Date: October 13, 2020
To: Planning Board
From: Kellie Walsh, Town Planner
Subject: ASRT, LLC (owner) and MVC Eye Care (applicant) – Review for acceptance and consideration of final approval for a site plan to construct a 5,654 square foot professional office building along with associated site improvements for MVC Eye Care. The parcel is located in the Integrated Commercial Industrial District. Tax Map 44, Lot 11-1.

Re: MVC Eye Care Site Plan (Tax Map 44, Lot 11-1) – Site Plan Review

We reviewed the thirteen-sheet plan set and the Stormwater Management Report both dated September 21, 2020 and prepared by The Dubay Group, Inc. in accordance with our agreement with the Town. Based on that review, we offer the following comments:

SHEET TITLE:
SITE PLAN
 PROJECT #444 SHEET 3 of 13

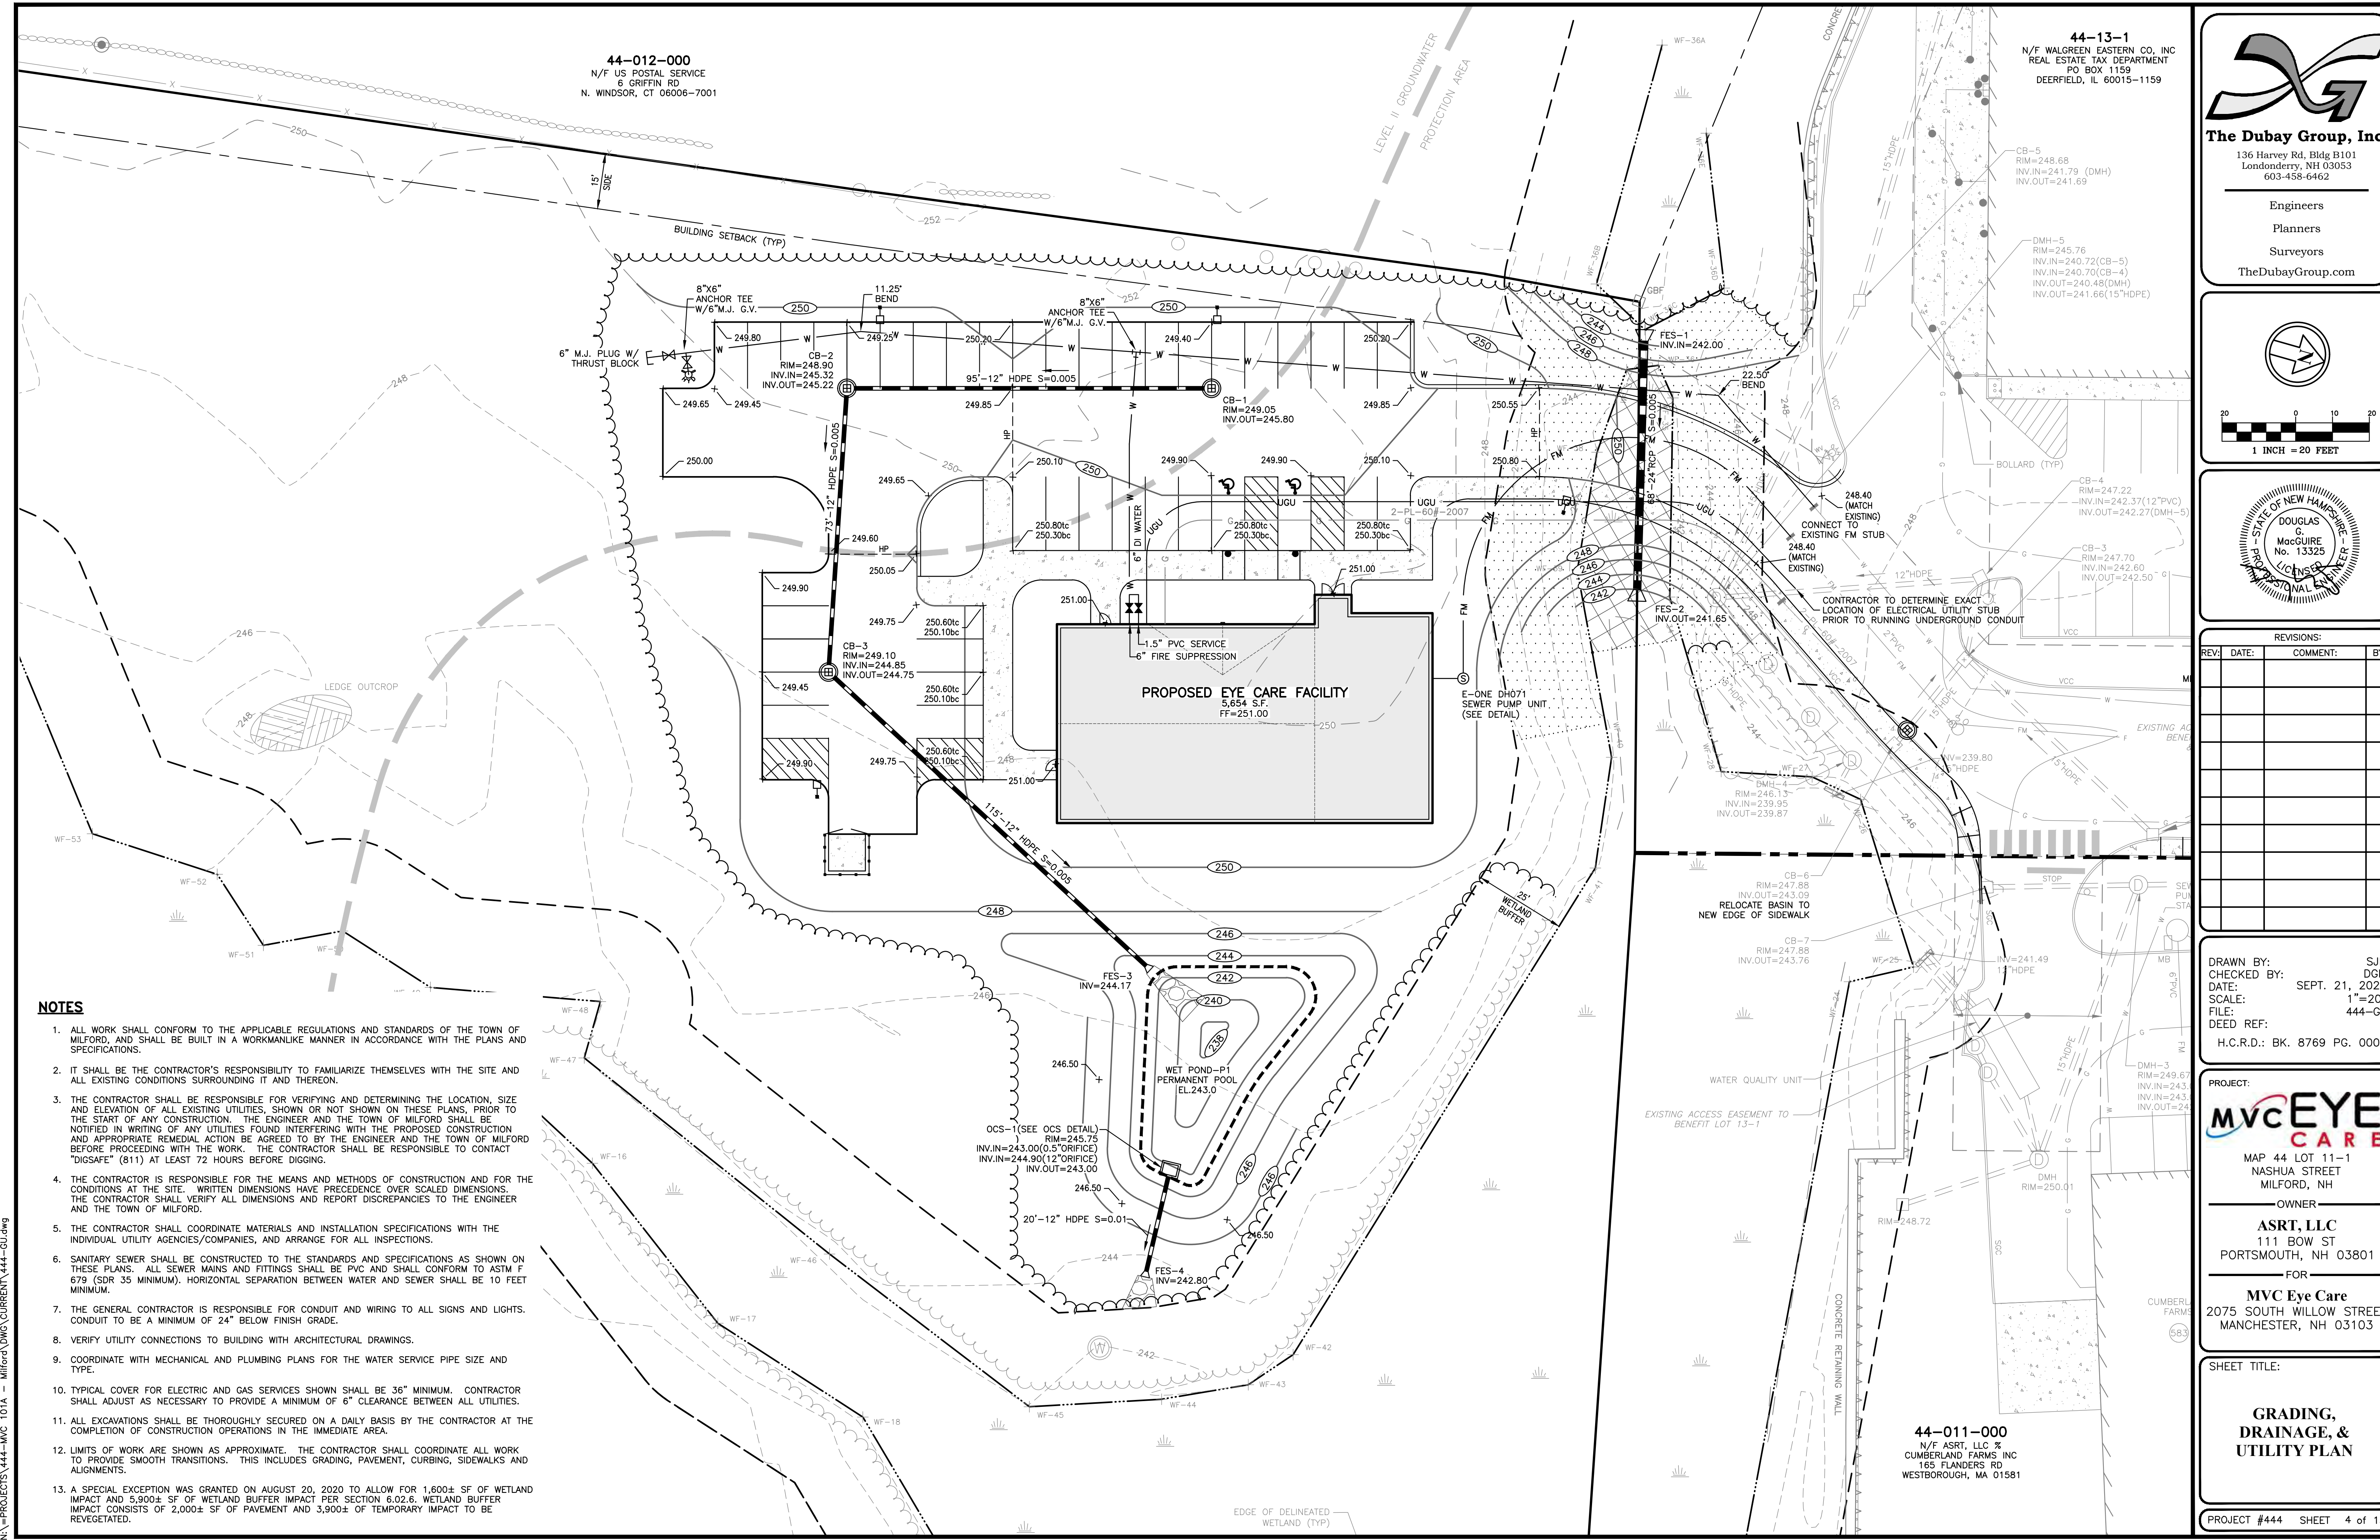
On Sheet 3, Note 15 states the owner is responsible for operation and maintenance of on-site drainage, including the wet pond.

Please clarify the responsible party for maintenance and inspection of the detention/retention basins.

SHEET TITLE:
SITE DETAILS-5

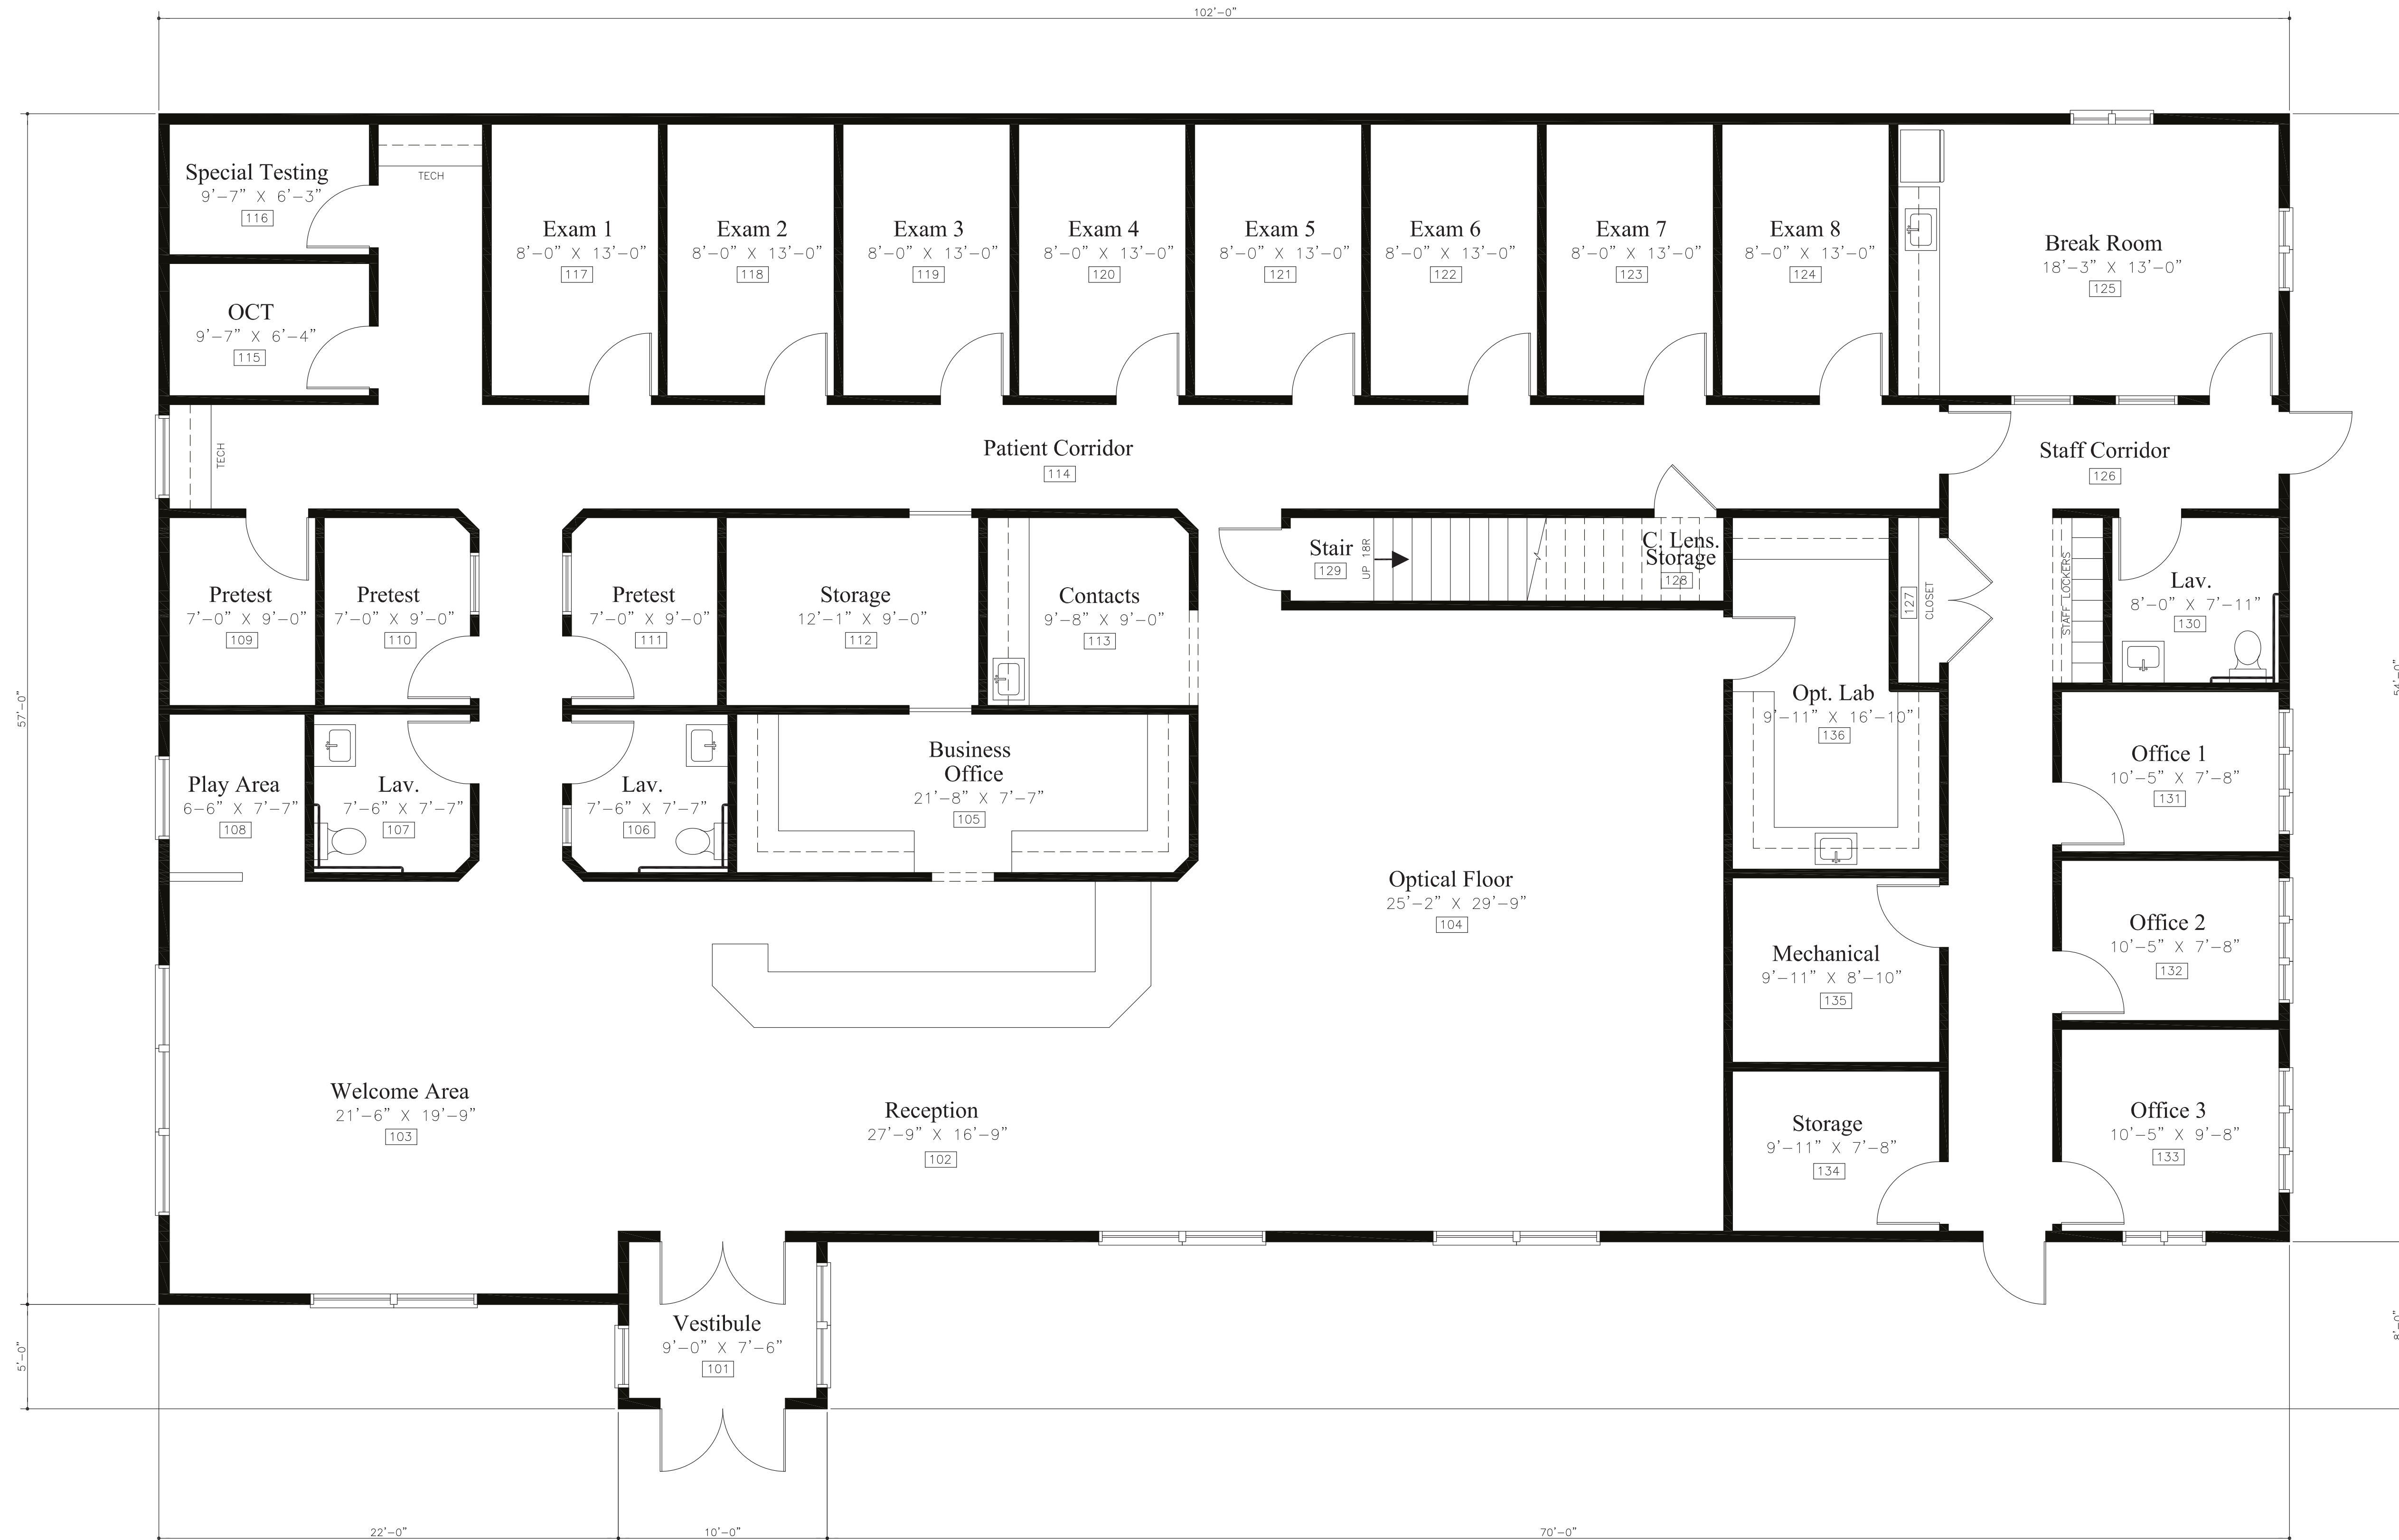
5. Site Plan. Drainage/Stormwater Management. Sheet 13, Maintenance note states a local government, designated group such as HOA or some individual must be assigned responsibility for maintaining the structures and basin area.

1. The proposed pond is a wet pond with an impervious liner. If the liner is needed to retain water (above the groundwater table) clarify why a wet pond is the correct stormwater measure for this location. If the liner is expected to be below the water table, clarify how there will be no water pressure from below the liner that may destabilize it should the pond dry out.

2. Depict the roof drain system on the plans to ensure it is constructed as planned.
3. The outlet structure includes notes that provide additional details (trash racks), but no corresponding notes were found. Please clarify.

4. The overflow spillway is shown on the stormwater basin detail and references an overflow detail and the plans for locations, however, that information was not shown.
